Access Compliance Report

Intersection ID: 29551	Main Street: WHITEHALL_PARK_DR	Cross Street: ARCO_CORPORATE_DR	Location: NW
ADA ID: A64DA5B30C19	Ramp Type: PerpDiag	Initial Pass/Fail: Fail	Overall Compliance: No
Severity Score: 13.75			
Codes/Mitigation Info/Possible Solution		Field Measurements/Component Compliance

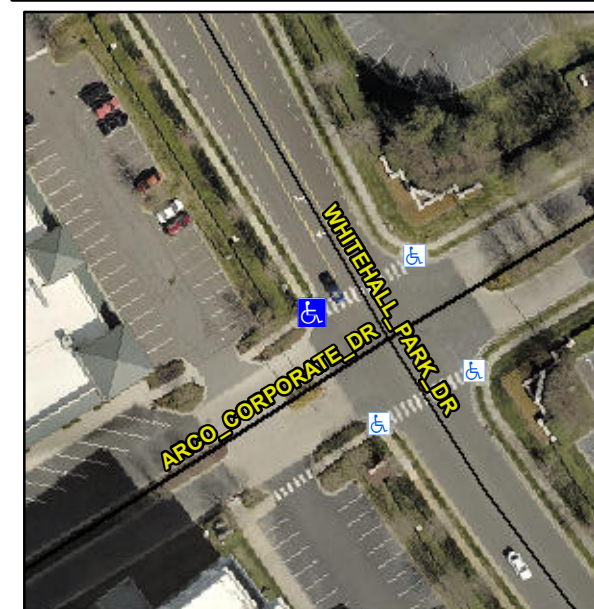
R304.2.2, R304.5.3

Compliance	Description	Data	Compliance	Description	Data
N/A	Ramp Length (in)	74.5	No	Ramp Slope (%)	8.8
Yes	Ramp Width (in)	48.5	No	Ramp XSlope (%)	2.4
N/A	Flare Type LT	N/A	N/A	Flare Type RT	N/A
N/A	Flare Slope LT (%)	N/A	N/A	Flare Slope RT (%)	N/A
N/A	Flare Traversable LT?	N/A	N/A	Flare Traversable RT?	N/A
N/A	Landing Length (in)	N/A	N/A	DWS Provided?	N/A
N/A	Landing Width (in)	N/A	N/A	DWS Contrast?	N/A
N/A	Landing Slope (%)	N/A	N/A	DWS Length (in)	N/A
N/A	Landing X Slope (%)	N/A	N/A	DWS Full Width?	N/A
N/A	Landing Curb? (Y/N)	N/A	N/A	DWS Offset (in)	N/A
N/A	Shared Landing?	N/A			
N/A	Gutter Ponding?	N/A	N/A	Gutter Slope (%)	N/A
N/A	Gutter Lip Ht (in)	N/A	N/A	Gutter X Slope (%)	N/A
N/A	Painted X Walk1?	No	N/A	Painted X Walk2?	Yes
	X Walk 1 Direction	To SE		X Walk 2 Direction	To NE
N/A	X Walk 1 Width (in)	N/A	N/A	X Walk 2 Width (in)	86.0
	X Walk 1 Slope (%)	0.4		X Walk 2 Slope (%)	1.6
	X Walk 1 X Slope (%)	4.3		X Walk 2 X Slope (%)	1.2

Remove & Replace Curb Ramp With Two New Directional Ramps or Equivalent.
